**Re: Initial Submission Review: Parklands Village 1 Phase 2 – Site Plan and Plat**  
**Application Number: DA-2289-06**  
**Case Numbers: 2024-4015-00; 2024-3028-00**

## Initial Submission Review

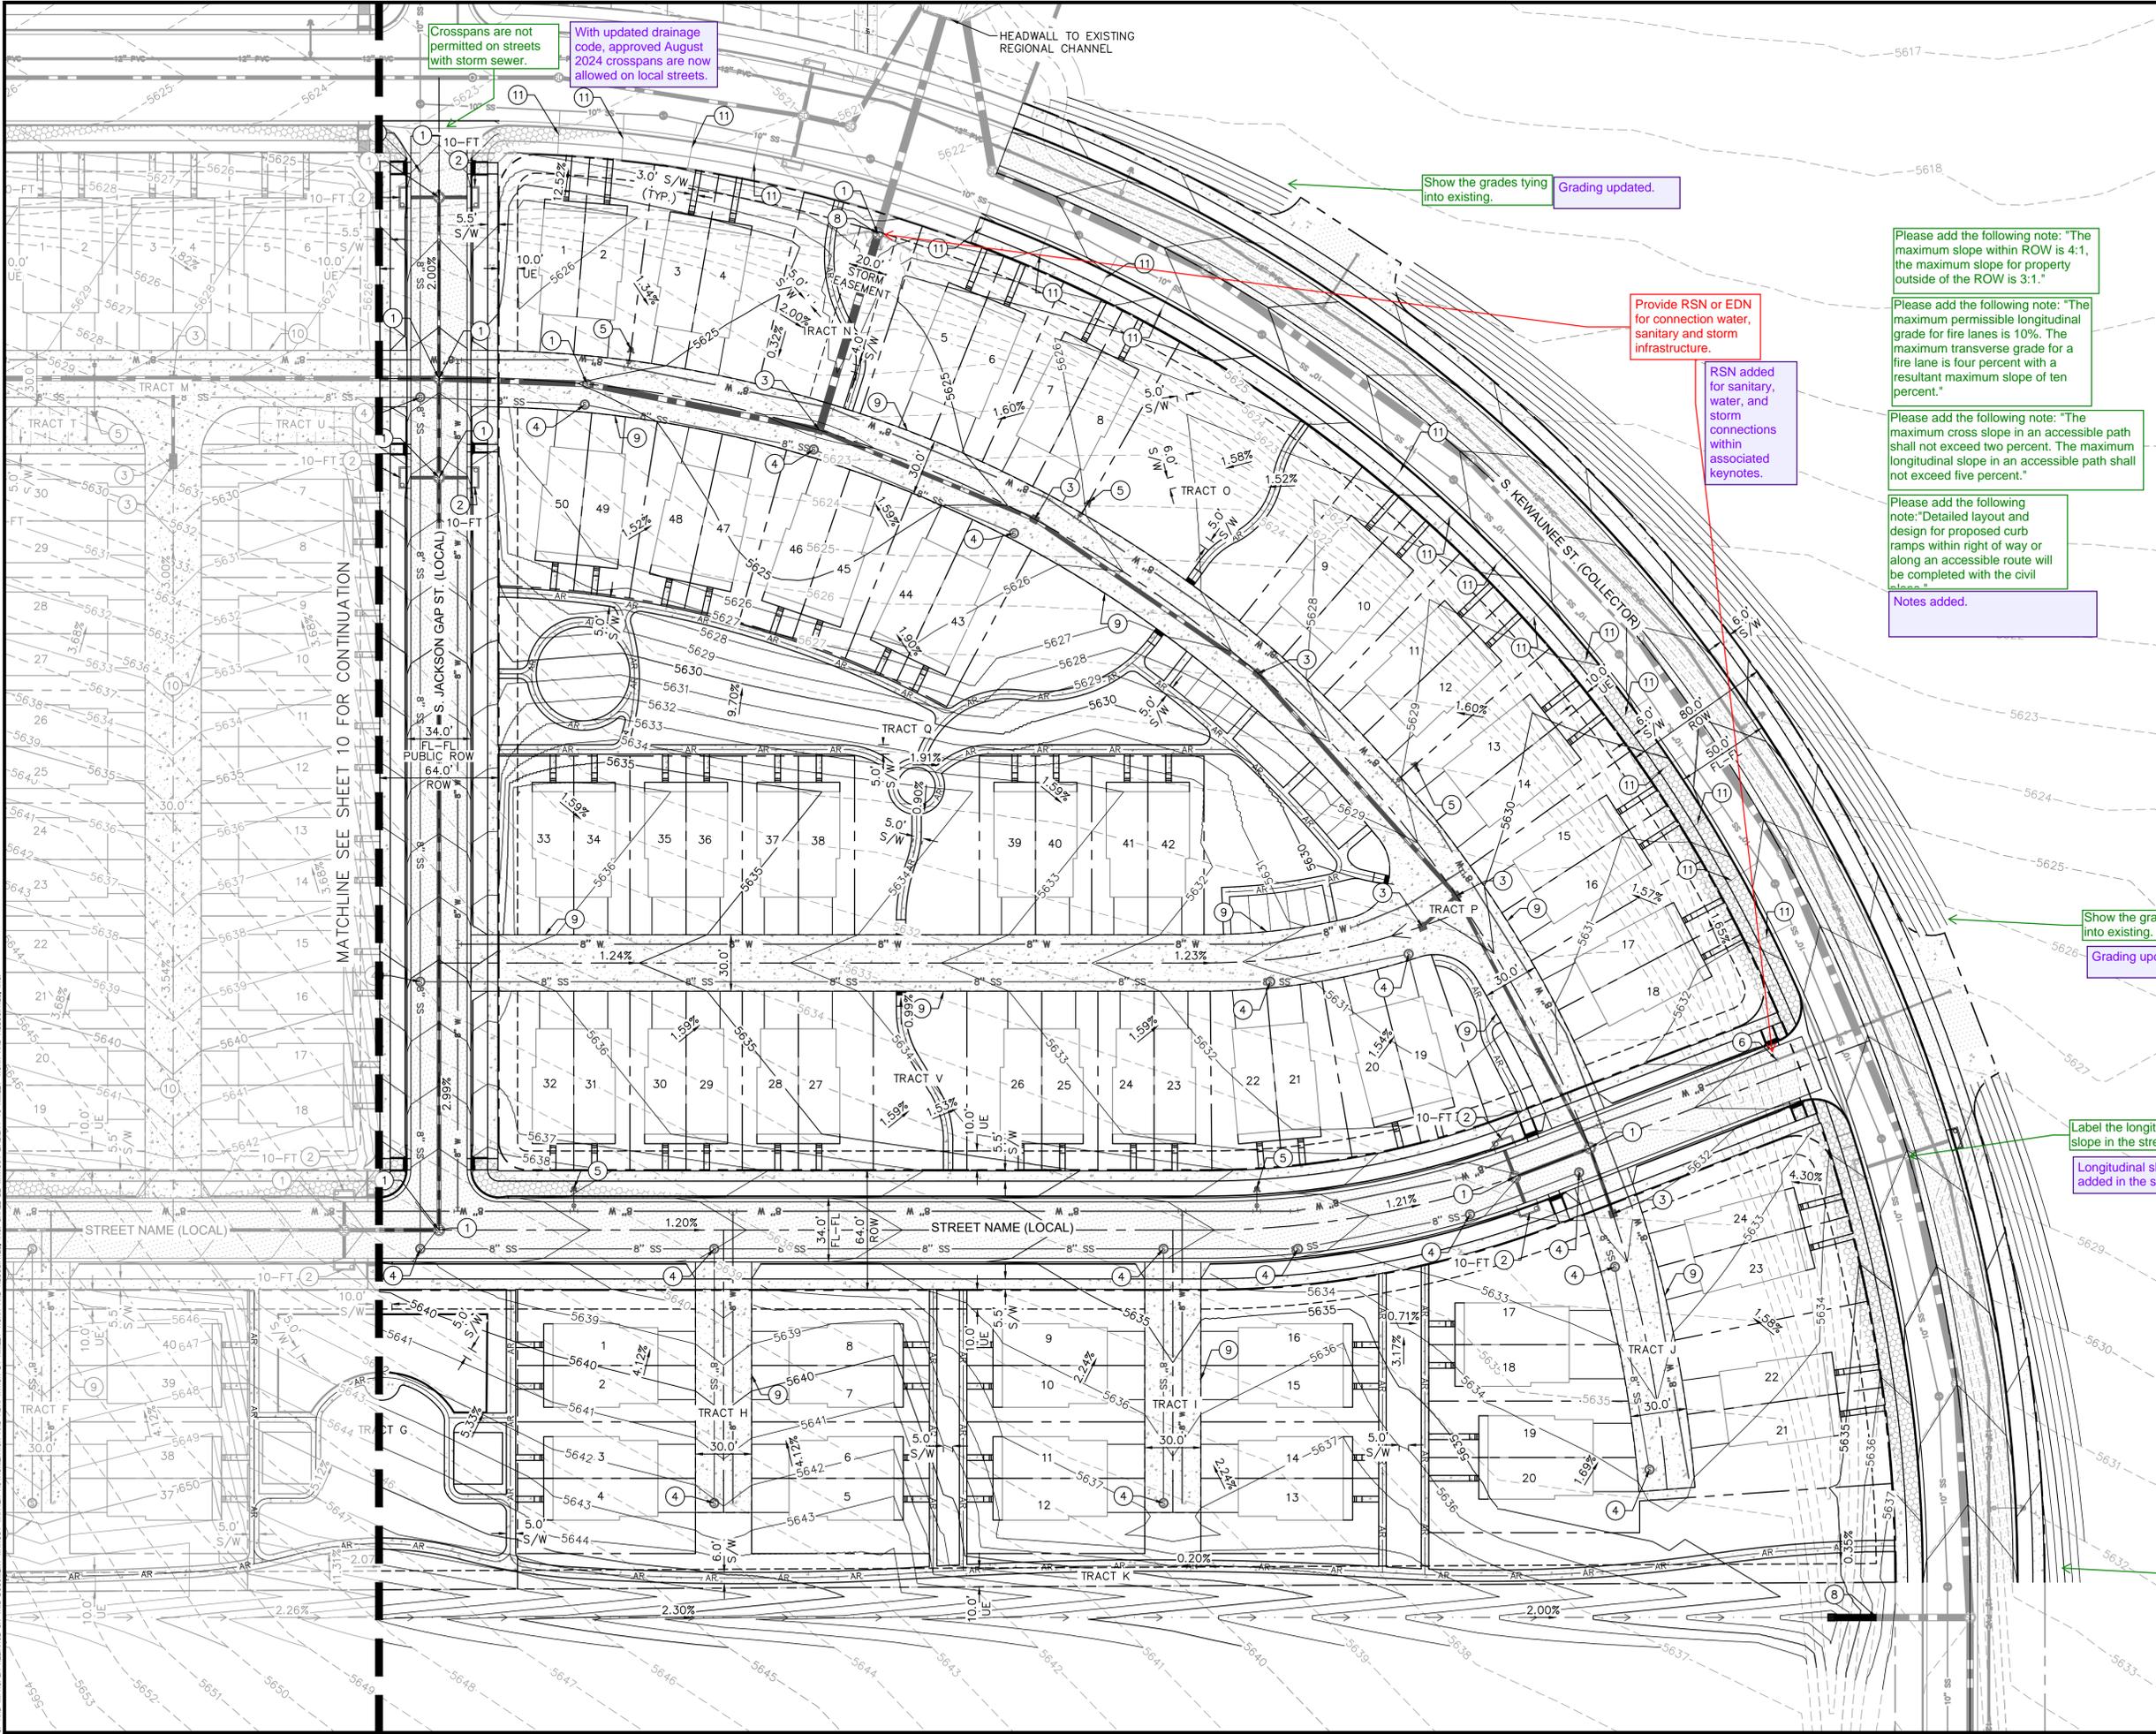
Label the longitudinal slopes of the alleys, typical.

Longitudinal slopes added to alleys.

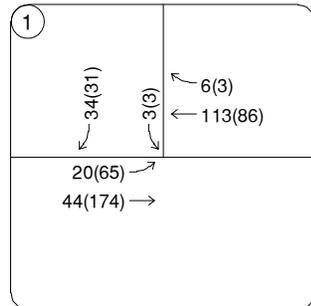
Where did the daily traffic counts come from? It is not listed in the report.

ADT estimates were derived from a 10% K-factor of the peak hour traffic volume.

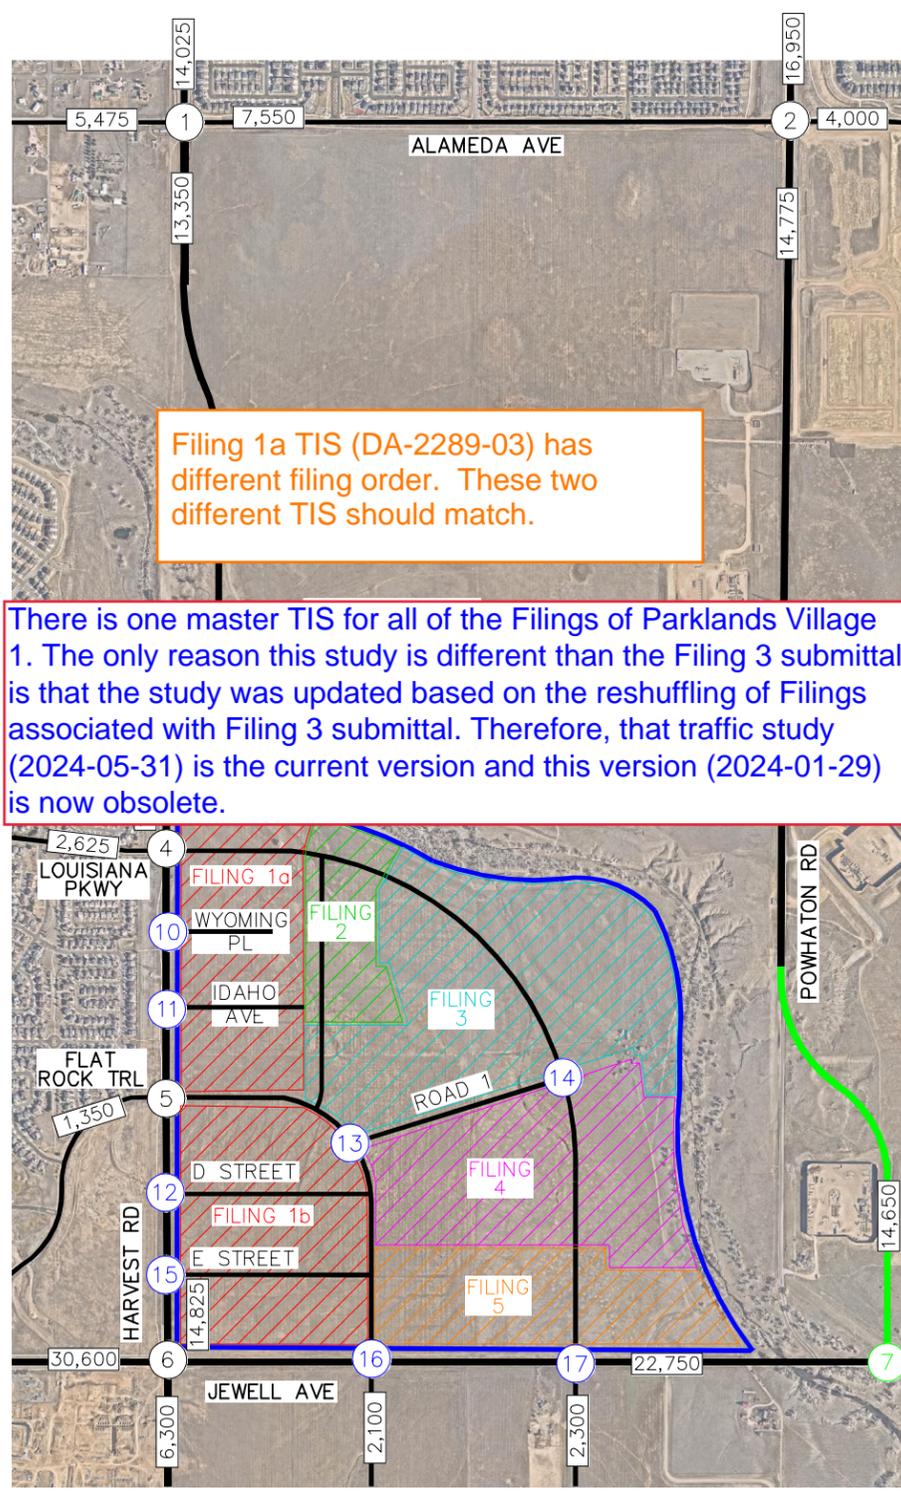
We want to know if you are using average or the linear equation.

Kimley Use of average rates versus fitted curve equations has been defined in the revised traffic study.

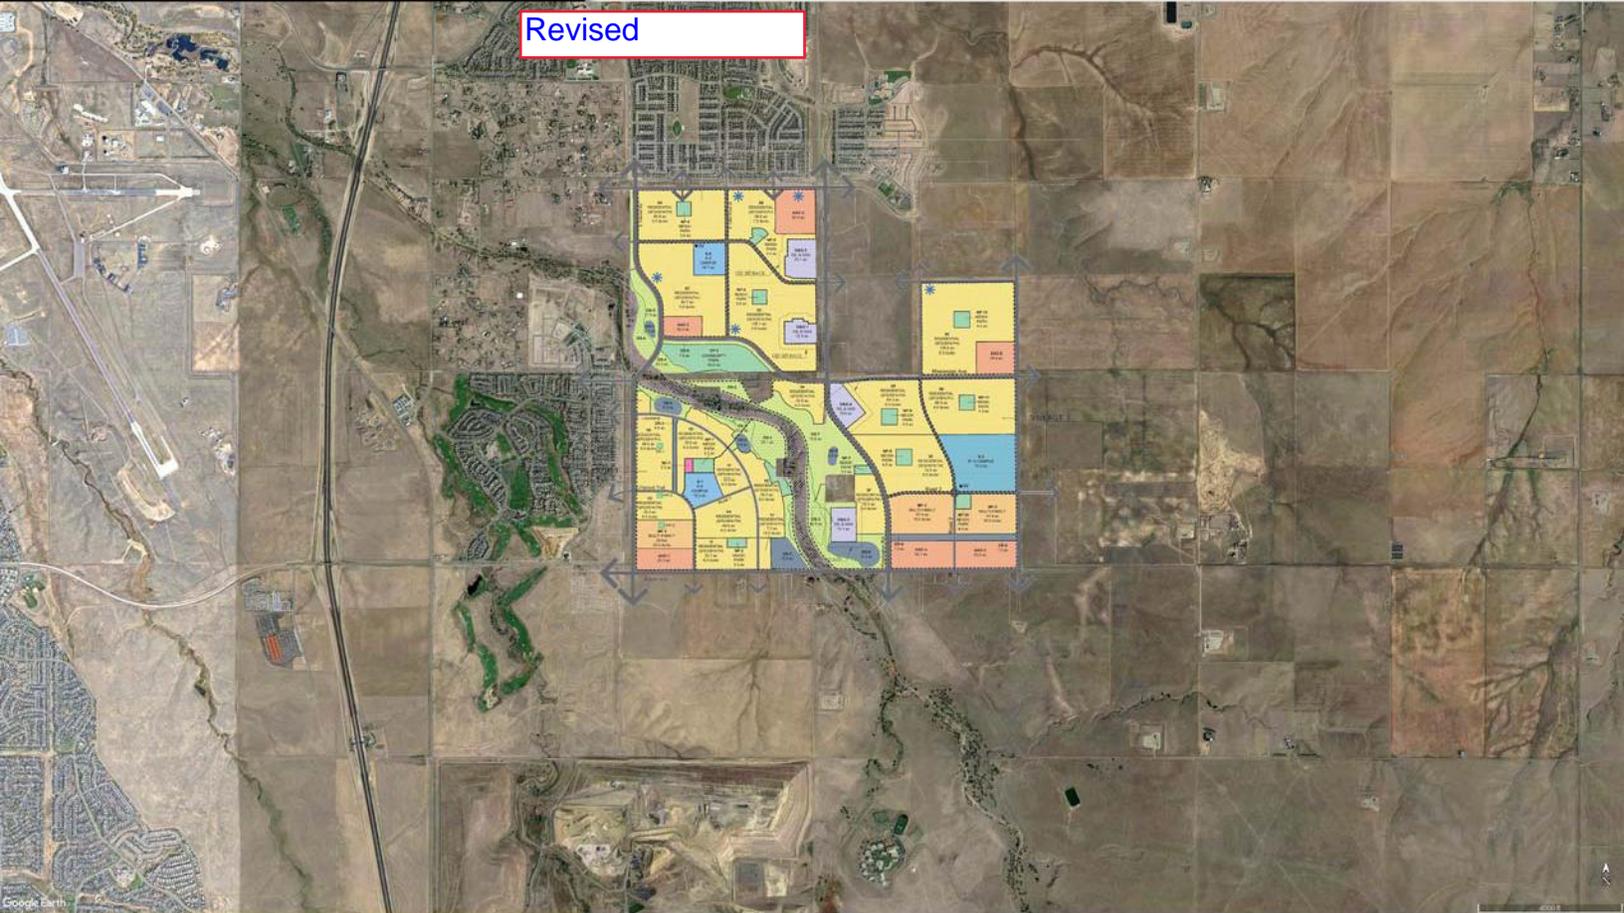
We don't need the full previous reports. Pairing this down the previous studies to coversheet, distribution, and trip assignment would be very helpful. I made remarks on what sheet to keep.
